South Marston Parish Council

Response to S/RES/24/1020: Primary Street

17/3/2025

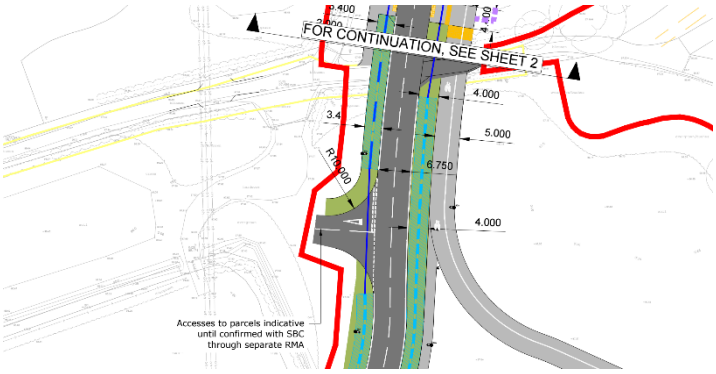
We note that some of the relevant plans may not have been posted on the portal. We appear to be missing any update of 'General Arrangements Sheet 1' – the original of which is shown to the right. We have accessed the updated Sheets 2 to 5 for the comments below. This missing sheet is of some concern as:

- The area of existing flooding (see below) would be covered on this sheet at the point where the notation says 'FOR CONTINUATION SEE SHEET 2'
- This sheet shows the most complex of all the junctions with multiple new footways, cycleways and bridleways converging on the existing Morses Lane (bordered by faint yellow lines) and Bridleway 4, both of which carry existing vehicle traffic across the Primary Street. It does not show the route of the secondary road going north to parcel R1, apart from the T junction. There is no movement analysis to show how it will work in conjunction with its existing use by vehicles, pedestrians and horse-riders. <u>By not showing clearly the complexity of that junction, mistakes in its design may be made as it has implications for traffic priorities, signage, safe crossings/visibility, lighting locations, and drainage.</u>

Catchpit underflow location R6/R8

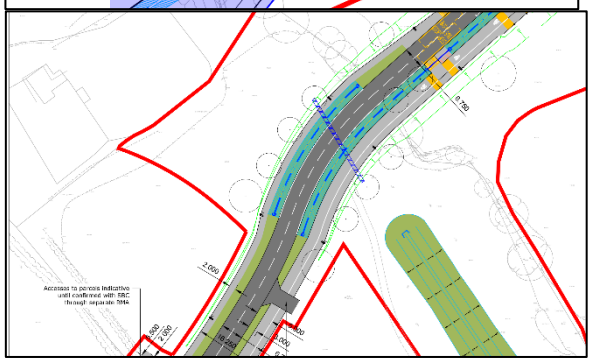
This is the Primary Street just north of Red House, with parcels R6 and R8 lying to the east of it. This is the line of the heaviest of the local surface water flow from north of the Leaze, under the Leaze culvert. The swale taking water away to the basin to the southwest does not start at the Primary Street itself, so we have to conclude that the pipe under the road will extend all the way into the main part of this swale.

We have discussed with Brookbanks their failure to take account of the surface water flow from the north. We were promised that, although the overall Surface Water Strategy was agreed, the appended note to the plan stated that additional swales/piping were required on the Bell Gardens field and area

between that and the Leaze, and these would be designed at a later date. We would assert that, given the visible impact of standing water throughout the winter to the north of the Primary Street route, **the capacity of pipes, catchpit and the swale must be sufficient to avoid flooding neighbouring properties**. It is worth noting that the existing property closest to this location (Red House) is the one which traditionally experiences regular internal flooding at present, as documented in the South Marston Flood Report produced in November 2023.

It would have been helpful to define these 'routes for surface water flow' rather than have to deduce them from local knowledge and hope that the capacity of the pipes is sufficient to safely direct flows into Basin A.
